REMARKS

Drawing Objection to under 37 CFR 1.83(a)

FIG. (a)

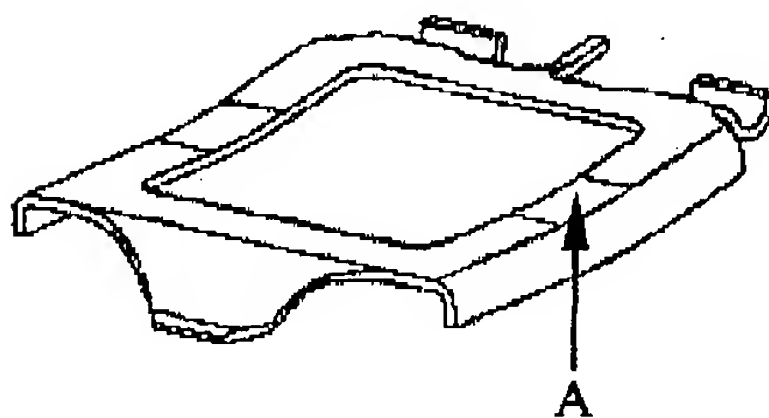
The drawings are objected to under 37 CFR 1.83 (a) since the drawings have not shown every feature of the invention specified in the claims. It is incorrect.

FIG. (a) is an isometric view of the metal clip shown in FIG. 1 of the original drawings, and FIG. (b) is an isometric, assembled view of the pick up cap and the metal clip in FIG. 3 of the original drawings. Referring to FIG. (a), a downwardly curved configuration signed with A in FIG. (a) has been shown. Referring to FIG. (b), a concave space formed above the downwardly curved configuration of the clip and signed with B in FIG. (b) has been shown.
